UNITED STATES PATENT AND TRADEMARK OFFICE

APPLICATION NO.	FILING DATE	FIRST NAMED INVENTOR	ATTORNEY DOCKET NO.	CONFIRMATION NO.
09/782,042	02/14/2001	Akira Yamaguchi	Q62085	8214

Office Action Summary

Attachment

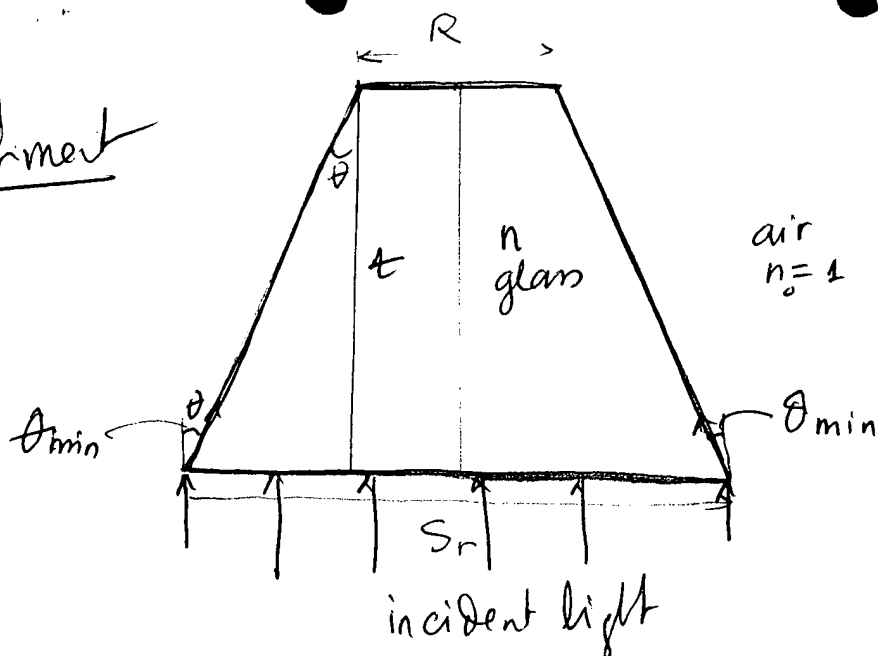
wherein when a refractive index of the lens substrate is represented by n ; a thickness of the lens substrate by t ; a diameter of each of the plurality of light entrance areas by R ; and a size of each of the plurality of micro lenses by S_r , the following formula : $S_r \geq 2t \times \tan\theta + R$ (with the proviso that $\theta = \sin^{-1}(1/n)$) is satisfied) [see attached sheet for this derived formula].

$$1) n \sin \theta_{\text{glass}} = n_0 \sin \theta_{\text{air}}$$

$$\text{if } \theta_{\text{air}} = 90^\circ \quad \theta_{\text{glass}} = \theta_{\min}$$

$$n \sin \theta_{\min} = n_0 \sin 90^\circ = 1 \cdot 1 = 1$$

$$\theta_{\min} = \sin^{-1} (1/n)$$

$$(2) \frac{(S_r - R)/2}{t} = \tan \theta_{\min}$$

$$S_r - R = 2t \cdot \tan \theta_{\min}$$

$$S_r - R \geq 2t \cdot \tan \theta \quad (\theta \geq \theta_{\min})$$

$$S_r \geq 2t \cdot \tan \theta + R$$
